# Access Compliance Report

## Public Rights-of-Way

### (Curb Ramps)

Intersection ID: 24180	Main Street: CANDLEWYCK_LN	Cross Street: STONERIDGE_RD	Location: NE
ADA ID: 34D9B8409FDD	Ramp Type: PerpDiag	Initial Pass/Fail: Fail	Overall Compliance: No
Severity Score: 25			
Codes/Mitigation Info/Possible Solution		Field Measurements/Component Compliance

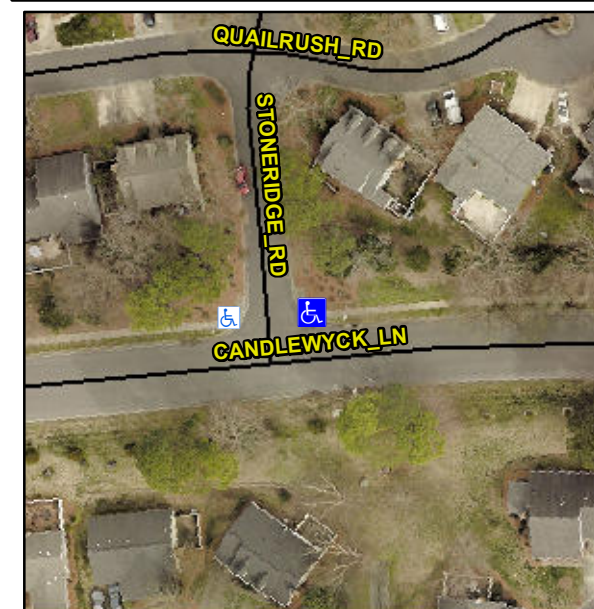
**Not Found, R304.2.2**

Compliance	Description	Data	Compliance	Description	Data
N/A	Ramp Length (in)	45.0	No	Ramp Slope (%)	14.9
Yes	Ramp Width (in)	48.0	Yes	Ramp XSlope (%)	1.6
N/A	Flare Type LT	N/A	N/A	Flare Type RT	N/A
N/A	Flare Slope LT (%)	N/A	N/A	Flare Slope RT (%)	N/A
N/A	Flare Traversable LT?	N/A	N/A	Flare Traversable RT?	N/A
N/A	Landing Length (in)	N/A	N/A	DWS Provided?	N/A
N/A	Landing Width (in)	N/A	N/A	DWS Contrast?	N/A
N/A	Landing Slope (%)	N/A	N/A	DWS Length (in)	N/A
N/A	Landing X Slope (%)	N/A	N/A	DWS Full Width?	N/A
N/A	Landing Curb? (Y/N)	N/A	N/A	DWS Offset (in)	N/A
N/A	Shared Landing?	N/A			
N/A	Gutter Ponding?	N/A	N/A	Gutter Slope (%)	N/A
N/A	Gutter Lip Ht (in)	N/A	N/A	Gutter X Slope (%)	N/A
N/A	Painted X Walk1?	No	N/A	Painted X Walk2?	No
	X Walk 1 Direction	To W		X Walk 2 Direction	To S
N/A	X Walk 1 Width (in)	N/A	N/A	X Walk 2 Width (in)	N/A
	X Walk 1 Slope (%)	0.0		X Walk 2 Slope (%)	2.1
	X Walk 1 X Slope (%)	1.9		X Walk 2 X Slope (%)	1.0

**Remove & Replace Curb Ramp With Two New Directional Ramps or Equivalent.**
